Re: St. Lucie Plant Unit 2  
Docket No. 50-389  
Renewed Facility Operating License No. NPF-16

Response to NRC Reactor Systems Branch and Nuclear Performance Branch Request  
for Additional Information Regarding Extended Power Uprate License Amendment  
Request

### **Response to NRC Reactor Systems Branch Request for Additional Information**

**Figure 1 - Total SG Liquid Volume vs. Time**

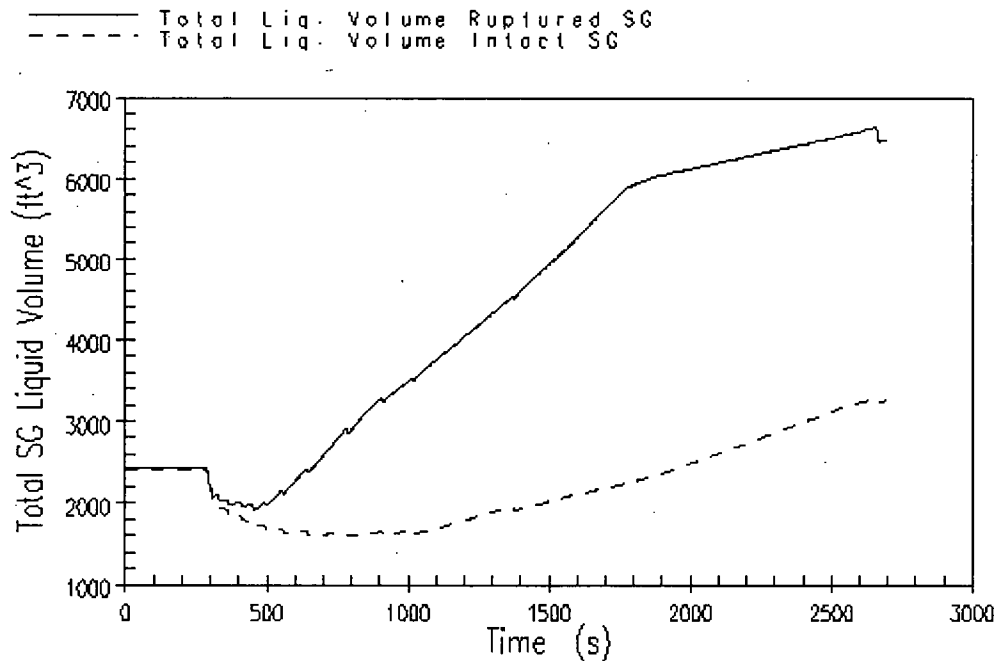
**Section 2.8.5.6.2 discusses the analysis of the steam generator tube rupture (STGR) event. However, it does not include an analysis to validate an assumption that the SG margin-to-overfill (MTO) exists. In addition, although the analysis of mass releases is discussed, additional information is needed as follows.**

**Perform an analysis to show that the SG MTO exists. Confirm that the computer code and methods used in the analysis are approved by the NRC, and address compliance with restrictions and conditions specified in the NRC safety evaluation report approving the computer code and methods. The requested information should include:**

The results of the analysis provided below demonstrate that SG MTO exists for St. Lucie Unit 2.

The sequence of events is presented in Table 1. Figure 1 shows the SG liquid volume as a function of time. The maximum SG liquid inventory is calculated to be 6631 ft<sup>3</sup>, which is below the SG overfill limit of ~7984 ft<sup>3</sup>, providing a margin of greater than 1,200 ft<sup>3</sup> to SG overfill.
